DEPARTMENT OF TRANSPORTATION
National Highway Traffic Safety Administration
49 CFR Part 571

Federal Motor Vehicle Safety Standards; Roof Crush Resistance

ACTION: Final rule.

Figure 1. Test Device Orientation

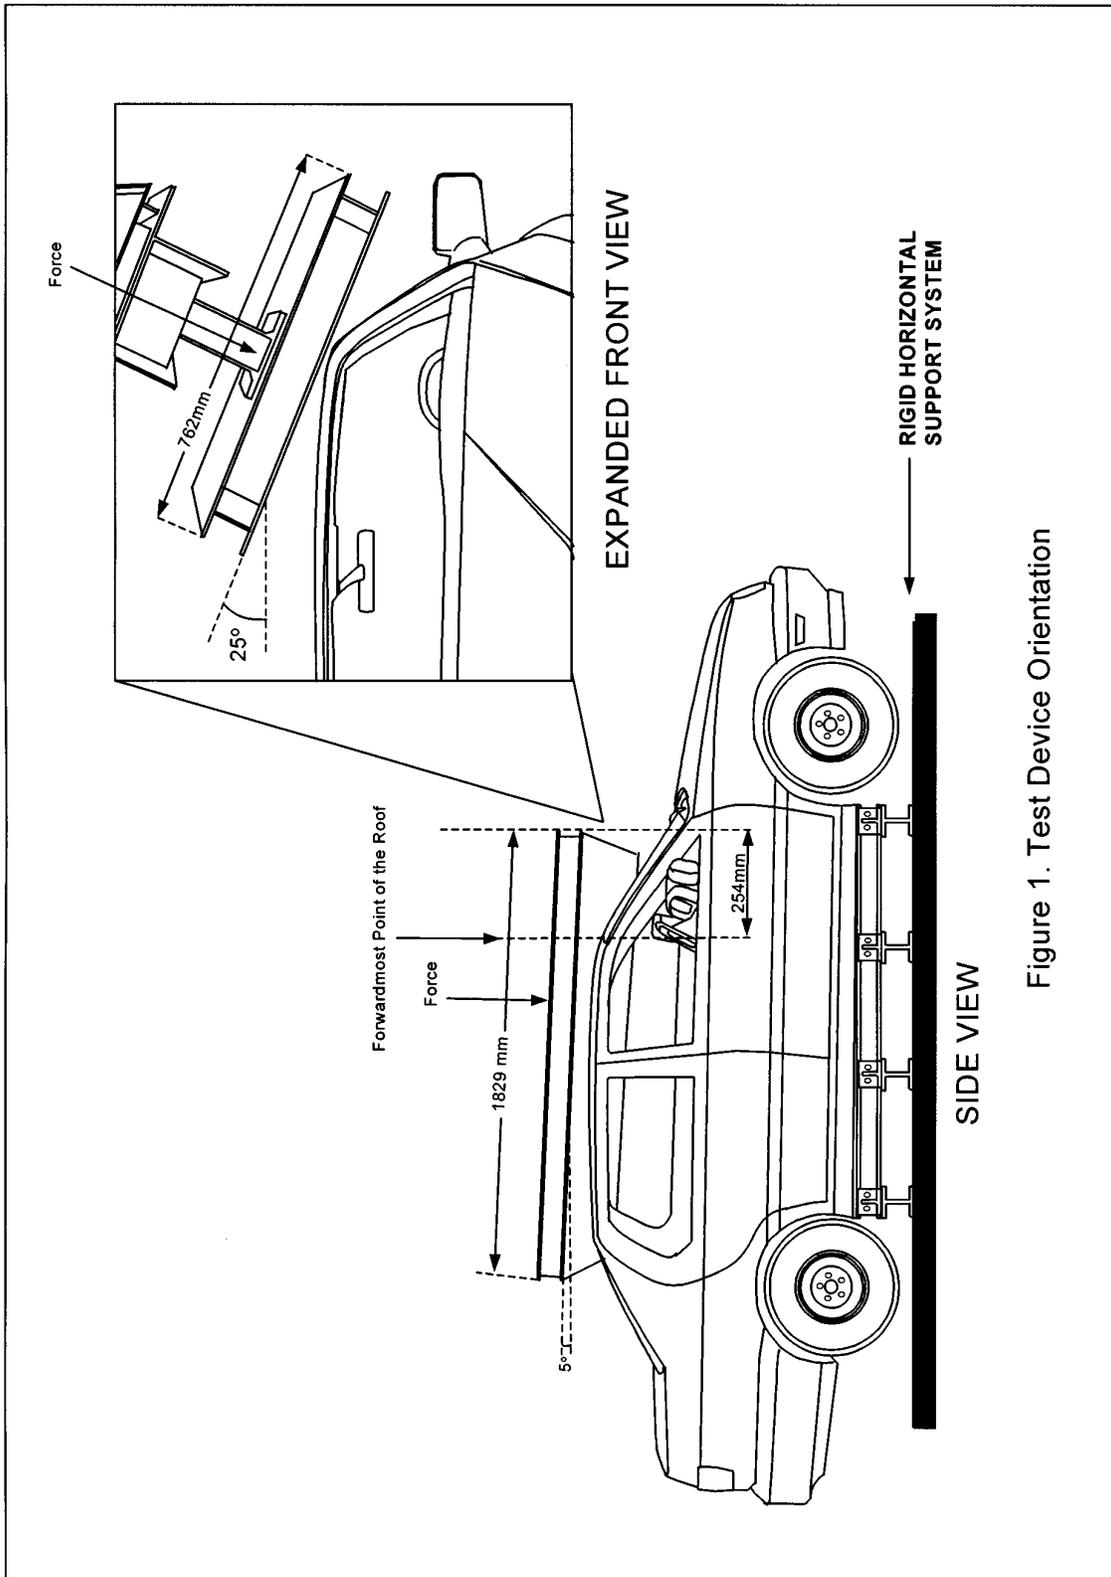
Paragraph S7.2 has been rewritten to clarify, but not change, the process of orienting the test plate and lowering so that it makes initial contact with the vehicle being tested. In addition, the agency is making a number of clarifying minor changes to the regulatory text. In particular, a sentence was added to the test procedures to explicitly specify that non-structural components such as roof racks are removed prior to testing. This was already the agency's interpretation of the current test procedure. The word "accidents" in S2 is replaced with the word "crashes." Figure 1 is revised to

- a. S2 is revised.
- b. S4 is revised.
- c. S5 is revised.
- d. S6 is revised, and S6.1, S6.2, 6.3 and S6.4 are removed.
- e. S7, S7.1, S7.2, S7.3, S7.4, S7.5, and S7.6 are added.
- f. A heading is added preceding Figure 1 at the end of the section and Figure 1 is revised.

S7.2 Orient the test device as shown in Figure 1 of this section, so that—

(2) Except as specified in S7.4, the midpoint of the forward edge of the lower surface of the test device is within 10 mm of the transverse vertical plane 254 mm forward of the forwardmost point on the exterior surface of the roof, including windshield trim, that lies in the longitudinal vertical plane passing through the vehicle's longitudinal centerline.

S7.4 If the vehicle being tested is a multipurpose passenger vehicle, truck, or bus that has a raised roof or altered roof, and the initial contact point of the test device is on the raised roof or altered roof to the rear of the roof over the front seat area, the plate is positioned so that the midpoint of the rearward edge of the lower surface of the test device is within 10 mm of the transverse vertical plane located at the rear of the roof over the front seat area.
